Reviewer's comments:

The authors addressed my comments and questions. That said, I think before publication a couple potential issues with the new section 4.2.2 should be addressed.

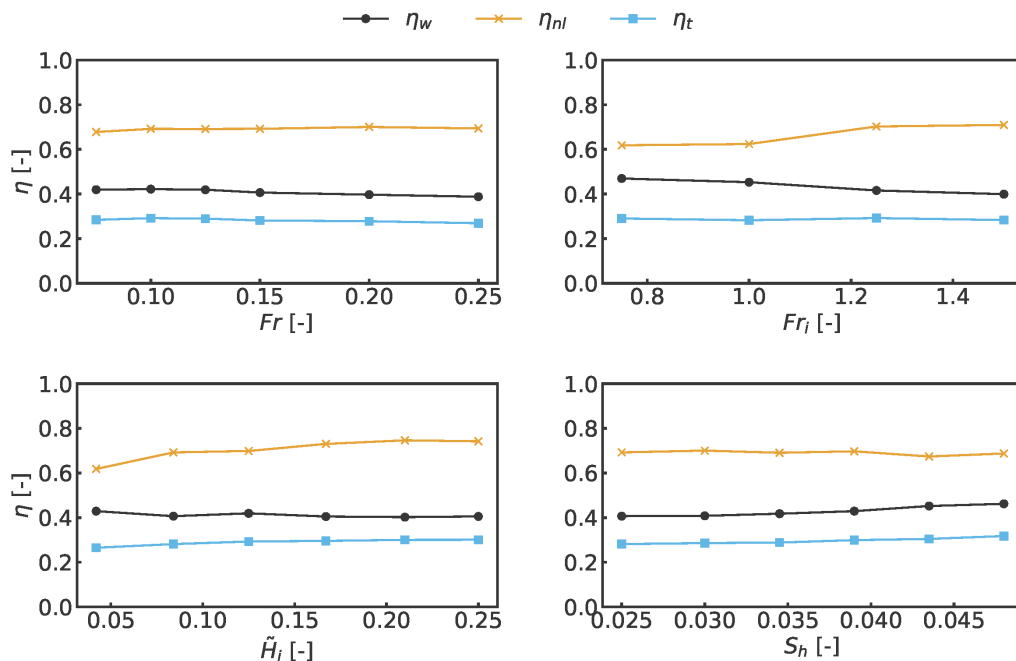
- (2) I think there is something wrong with the  $\eta_w$  values in Figure 17 (and in turn the  $\eta_t$  values). The  $\eta_w$  values are just too low (below 0.1). If I estimate  $\eta_w$  from power values approximated from Figure 16a, I come up with an  $\eta_w$  (wake efficiency) of around 0.38. (My estimate assumes the average power of the first row turbines is 7 MW and the average power of the remaining turbines is 2.2 MW.)

The reviewer has rightly spotted this mistake, which we have corrected, as seen in the updated figure 17 that is given below. The mistake in wake and total efficiency was dividing the sum of row-averaged power by 50 turbines instead of 10 rows. Thus, both wake and total efficiencies were mistakenly scaled down by a factor of 5.
